Appendix F – Road Safety Audit Designer’s Responses

Adastral Park, Ipswich : Eastern Priority Junction Access off Ipswich Road

Technical Note : Designer's Response to Road Safety Audits at Stage 1

13th June 2017

10391-H-05 Rev C	Proposed Priority Junction - Western Access
10391TA01Rv2	Land South and East of Adastral Park - Transport Assessment

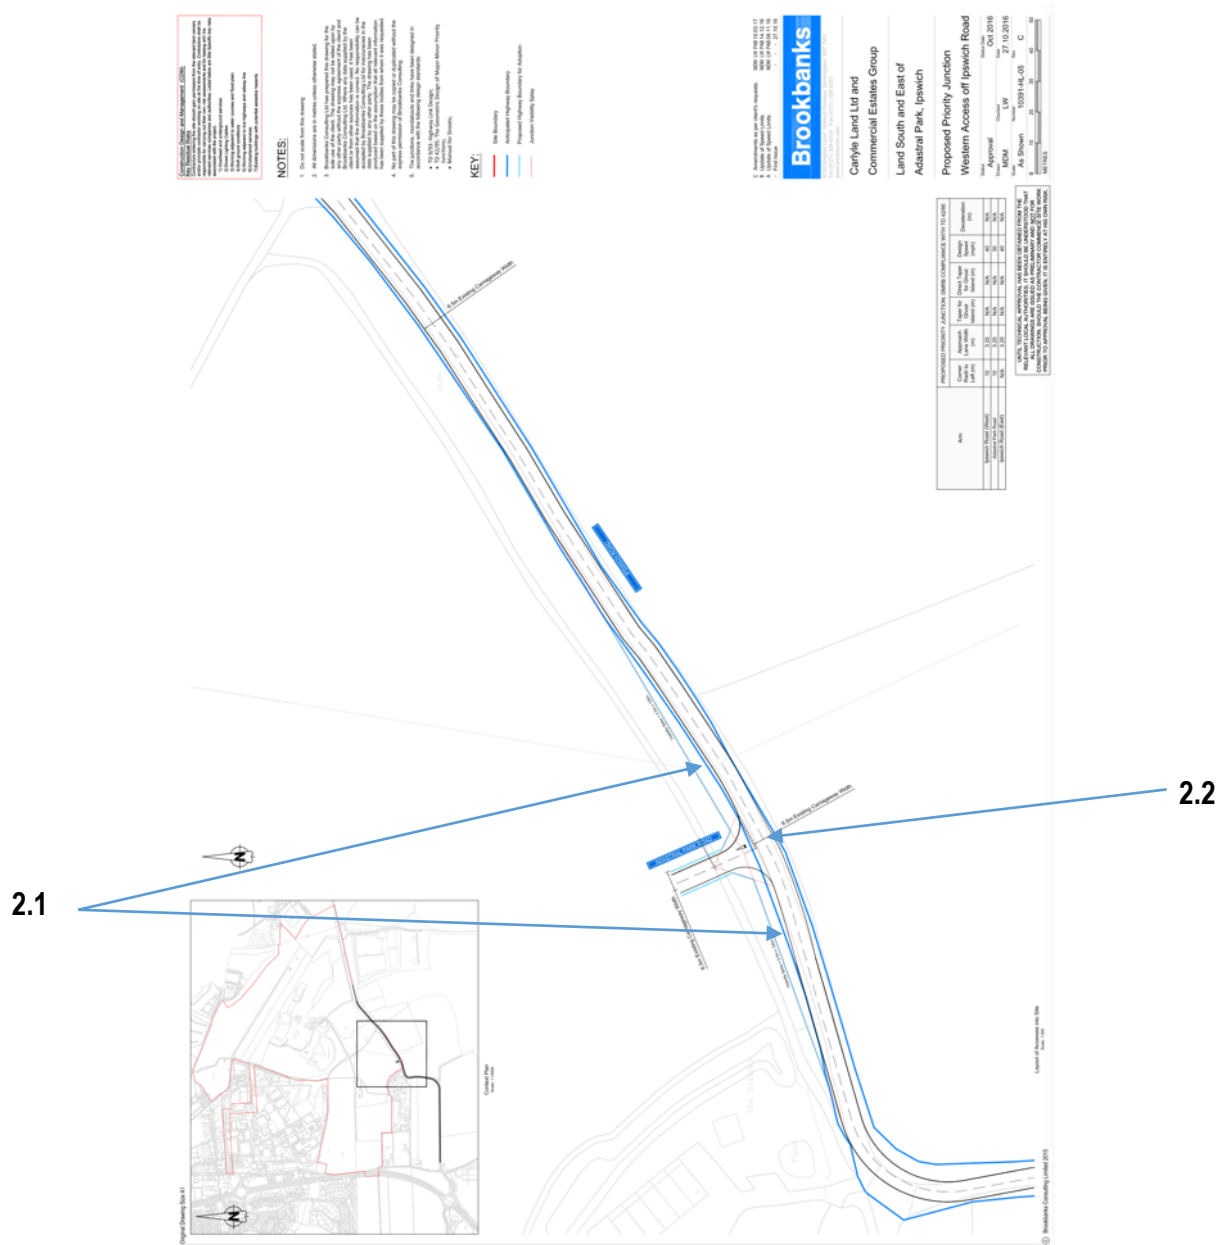
Location: Ipswich Road / proposed western access

Summary: Visibility is obstructed

There are a large number of significant sized trees in the vicinity of this junction which may obstruct visibility.

RECOMMENDATION

Measure the visibility at a setback of 2.4 metres and specify the removal of any trees which fall within this.

2.2 PROBLEM

Location: Ipswich Road / eastern access

Summary: Junction form may not be adequate.

Traffic flows were not available for this junction. As this access serves a significant size site it may require a ghost island.

RECOMMENDATION

Assess the projected flows and provide a ghost island if the numbers merit it.

BCL Response: *The vegetation clearance including trees has been specified for this site through an arboricultural survey. This has resolved that any trees blocking the visibility splay are not protected and therefore can be removed.*

BCL Response: *It has been demonstrated through Paramics modelling that the proposed junction will work adequately with respect to traffic flows, as there is minimal queuing from Ipswich Road to the east wishing to turn into the site. This is attributable to the road being lightly trafficked and not serving a substantial area.*

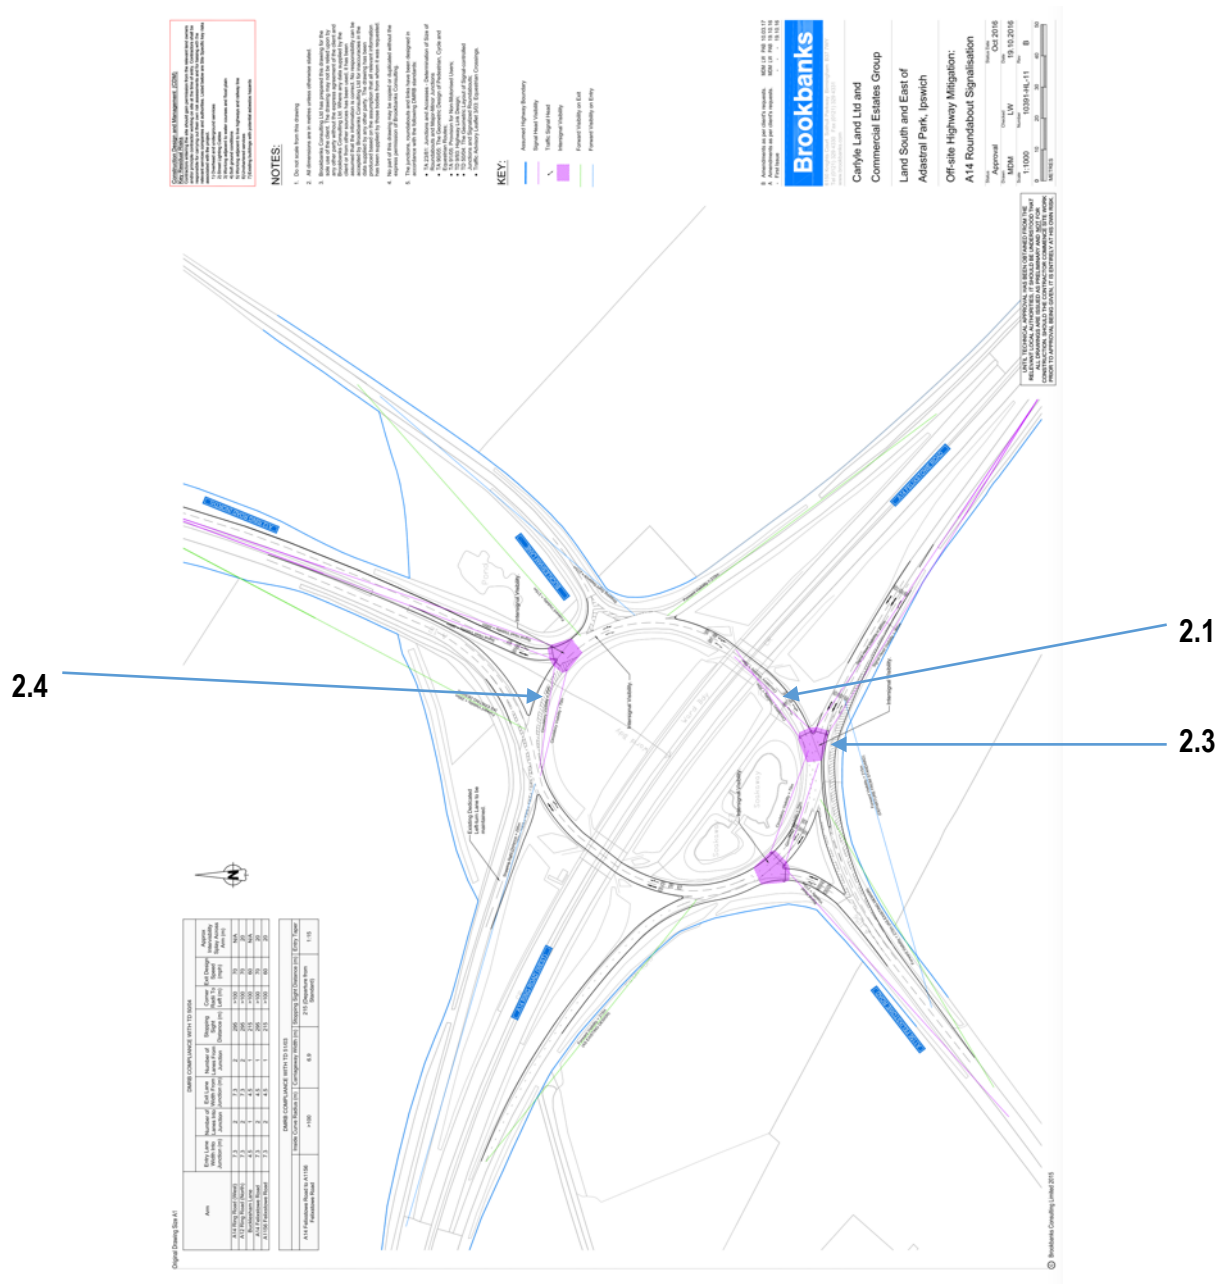
Location: Circulatory carriageway / A14 westbound exit slip

Summary: Likelihood of shunt accidents or failure to comply with signals.

The visibility of the offside signals for drivers in the offside lane by the bridge parapet and as there is a significant risk of the nearside signal being obstructed by high sided vehicles, drivers in the offside may not appreciate the presence of the signals in time.

2.3 PROBLEM

Location: Dedicated left-turn lane, A14 to A1156

Summary: Risk of vehicles striking kerb or signal head.

With kerbed dedicated lanes, vehicles are known to strike the kerb which can result in loss of control or overturning for high sided vehicles. This hatching means that vehicles approach in the straightest line possible and then drive directly adjacent to the kerb following the tightest radius around this bend. They are also running directly next to the nearside signal head, which is sited on this relatively narrow feature.

2.4 PROBLEM

Location: Circulatory carriageway / A12 ring road.

Summary: Risk of sideswipes and shunts (and non-compliance with stopline).

The circulatory carriageway is reduced down to one lane on approach to the signals with the A12 entry. The hatching appears to create a pinch point for the two exit lanes to the A12 Ring Road which could lead to sideswipes. It also reduces stacking capacity at the signals which could result in queuing back into the offside exit lane, which if not anticipated could result in high speed shunts. (The layout also appears to show the stopline not extending from kerb to kerb, which means vehicles can legally cross the hatching against a red light.)

Status			Status Date		
Approval			Oct 2016		
Drawn		Checked	Date		
MDM		LW	19.10.2016		
Scale		Number	Rev		
1:1000		10391-HL-11	C		
<div><div>01020304050</div><div>METRES</div></div>

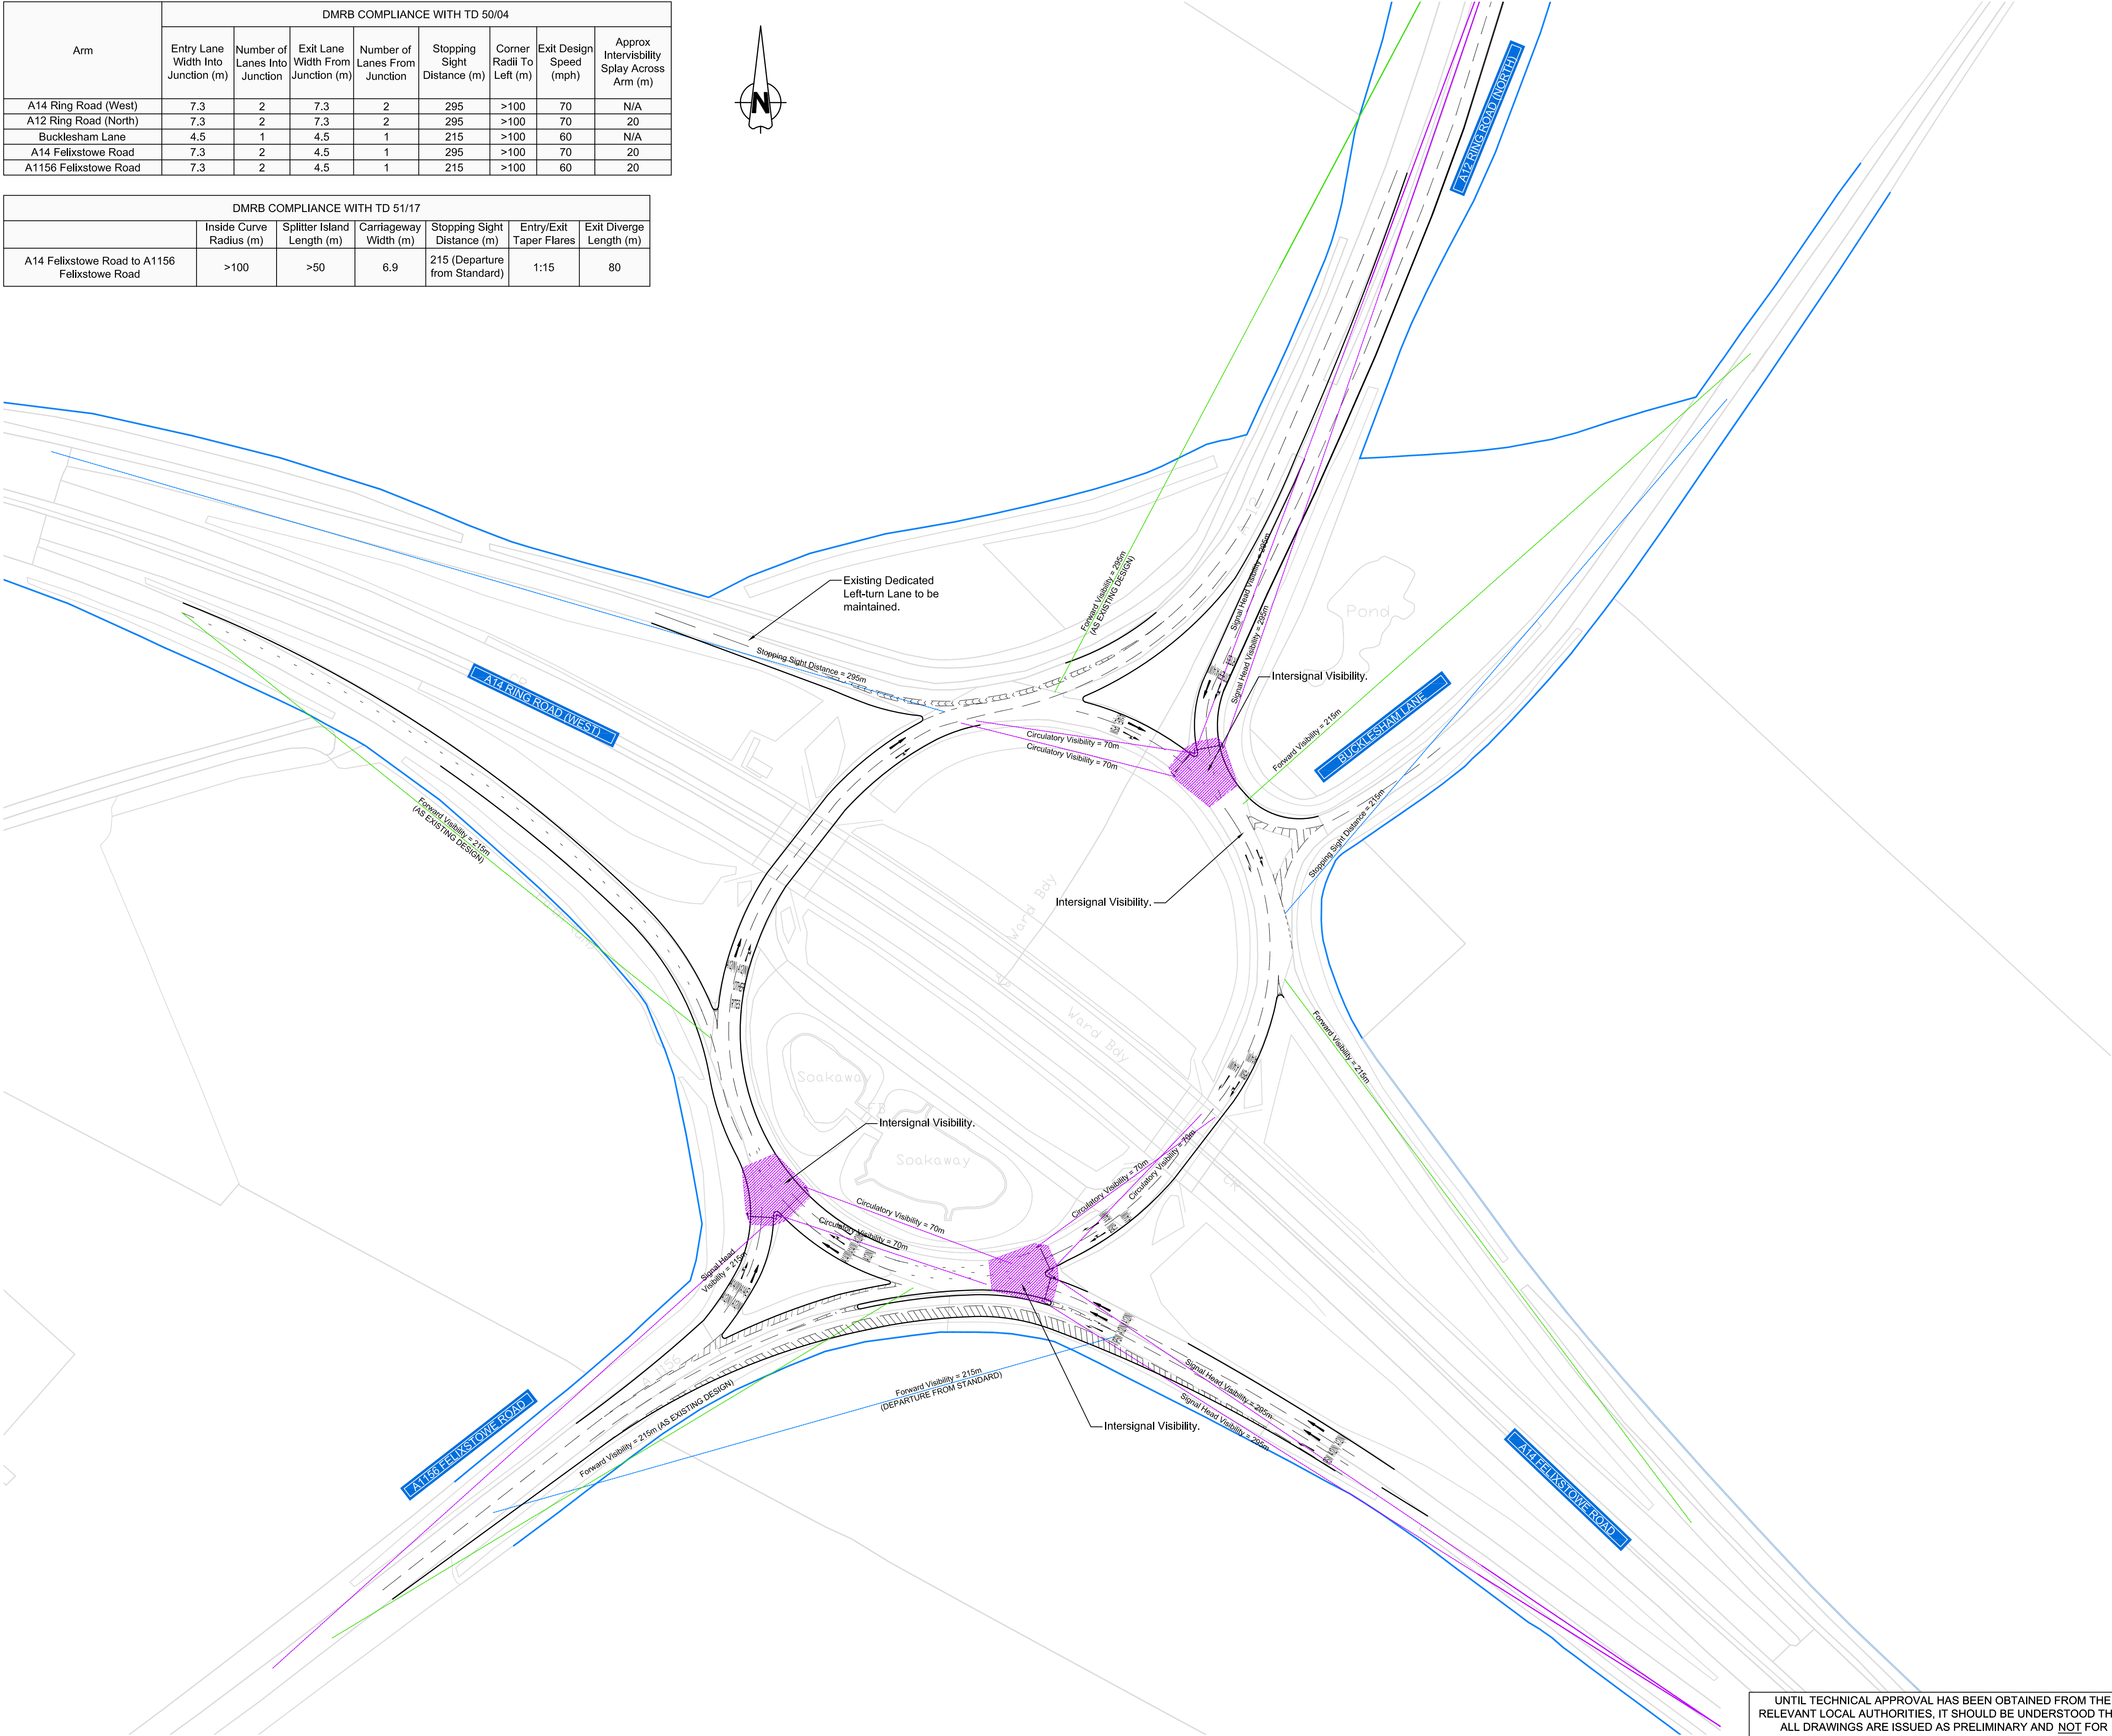
Location: Circulatory carriageway / A14 westbound exit slip

Summary: Likelihood of shunt accidents or failure to comply with signals. The visibility of the offside signals for drivers in the offside lane by the bridge parapet and as there is a significant risk of the nearside signal being obstructed by high sided vehicles, drivers in the offside may not appreciate the presence of the signals in time.

Recommendation: Provide a signal layout which ensures that drivers in the offside lane will have a view of at least one signal head at the requisite distance. One solution would be the provision of a mast arm.

Location: All approaches to signals.

Summary: Mature trees (and other vegetation) obstruct visibility. There are a significant number of large trees (and other vegetation) which obstruct the various visibility splays required. These splays need to be cleared and kept clear for the life of the signals.

Problem 3

Location: Dedicated left-turn lane, A14 to A1156

Summary: Risk of vehicles striking kerb or signal head. With kerbed dedicated lanes, vehicles are known to strike the kerb which can result in loss of control or overturning for high sided vehicles. This hatching means that vehicles approach in the straightest line possible and then drive directly adjacent to the kerb following the tightest radius around this bend. They are also running directly next to the nearside signal head, which is sited on this relatively narrow feature.

Recommendation: Swap the start of the nearside hatching to the offside of this lane which will also achieve better segregation between this and the adjacent signalised ahead lane. Continue the hatching around on the kerbed side, increasing the distance between the running area and the kerbs and signal head. The hatching should be then provided on both sides to create the largest radius path around this bend. At detailed design, reflective features should be provided along the length of the kerbed island to minimise the chance of it being struck by vehicles, both turning left and exiting the circulatory.

Location: Circulatory carriageway / A12 ring road.

Summary: Risk of sideswipes and shunts (and non-compliance with stopline). The circulatory carriageway is reduced down to one lane on approach to the signals with the A12 entry. The hatching appears to create a pinch point for the two exit lanes to the A12 Ring Road which could lead to sideswipes. It also reduces stacking capacity at the signals which could result in queuing back into the offside exit lane, which if not anticipated could result in high speed shunts. (The layout also appears to show the stopline not extending from kerb to kerb, which means vehicles can legally cross the hatching against a red light).

Recommendation: Provide two lanes on this approach, removing the hatching.

BCL Response: *High-mast traffic signals have now been provided on the A14 Westbound Off-slip approach as advised.*

BCL Response: *All trees and other vegetation that hinder visibility to traffic signal heads are recommended to be cropped back and maintained on a regular basis.*

BCL Response: *In TD 51/17 for the design of Segregated Left turn Lanes and Subsidiary Deflection Islands at Roundabouts, hatching is advised to be on the nearside of the curve in Paragraph 2.5.10. In addition, placing the hatching on the off-side would reduce forward visibility for vehicles travelling along this lane outside of the hatched area. Reflective features will be discussed at detailed design stage.*

BCL Response: *This has now been amended to reflect this observation.*

B Amendments as per Road Safety Audit. MDM LW PAB 12.06.17
B Amendments as per client's requests. MDM LW PAB 10.03.17
A Amendments as per client's requests. MDM LW PAB 19.10.16
- First Issue - - - 19.10.16
